Please see below for a further response to the Request for Further Information (RFI), issued on 24 May 2024 for the resource consent applications CRC242267, CRC242268 and CRC242269, made by Christchurch City Council (CCC) relating to the Southshore and South New Brighton Inundation Protection Project.

2. Ecological Values

Figure 5. The six seabed cross sections along Southshore that were used for the coastal squeeze assessment. The mapping of seagrass and other features was carried out by NIWA in 2024².

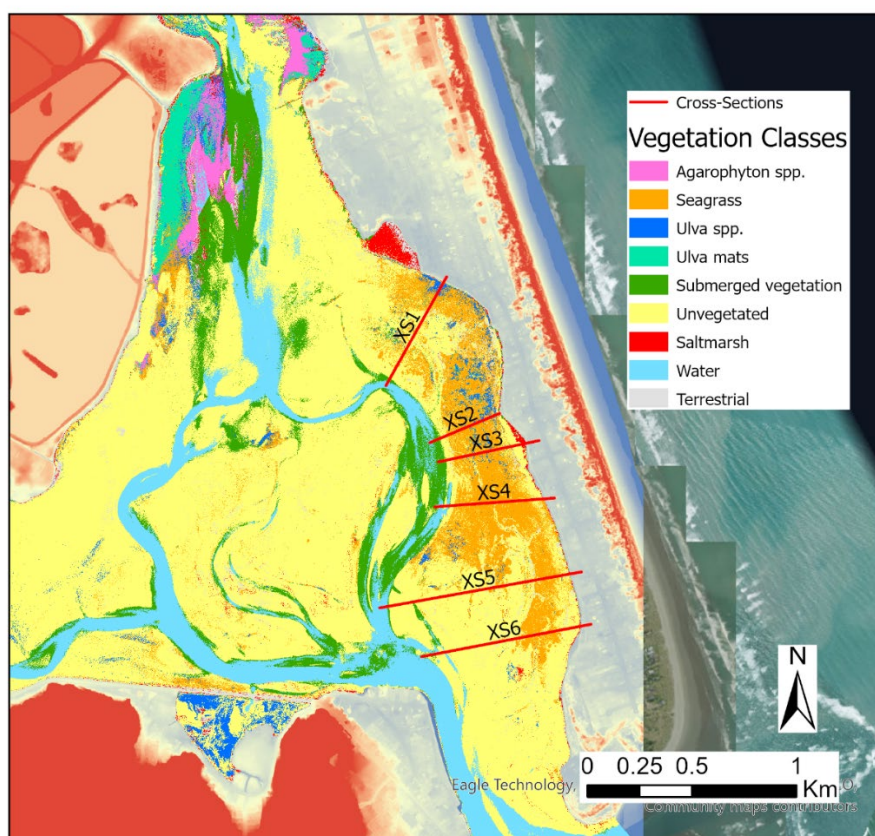
The CRC experts state that they disagree with the assessment that the effects of coastal squeeze along Southshore will be very low and consider that it will be moderate to high. They consider that the hard-walled structures will not only act as a barrier and prevent the inland migration of habitats and organisms but are likely to result in increased water depths throughout the intertidal area from sea level rise. These increased water depths may limit light availability and intensify wave action which are both unfavorable for seagrass (Keyser et al., 2020). This may result in loss of seagrass habitats and the ecosystem services they provide.

There are wide margins between the current houses and the estuary edge which could be used to allow a natural edge and for the seagrass habitats to survive and expand. Seagrass beds not only sequester and store organic carbon in the sediment acting as natural carbon sinks (Serrano et al., 2021) reducing the effects of climate change, but they also encourage sediment stabilisation and surface elevation making them a natural coastal defence (Potouroglou et al., 2017).

- h. Please provide an assessment on coastal squeeze which gives consideration to the inclusion of a natural edge at areas along Southshore to allow for the natural migration of seagrass beds.*

In response to this RFI, we have assessed coastal squeeze effects on seagrass. We have combined information on seagrass distribution, vertical land movement of the estuary bed and sea level rise projections as outlined in the memo prepared by NIWA and included in Appendix 1. This assessment is based on six seabed cross sections along Southshore (Figure 5) and assumes the presence of a hard estuary edge along Southshore.
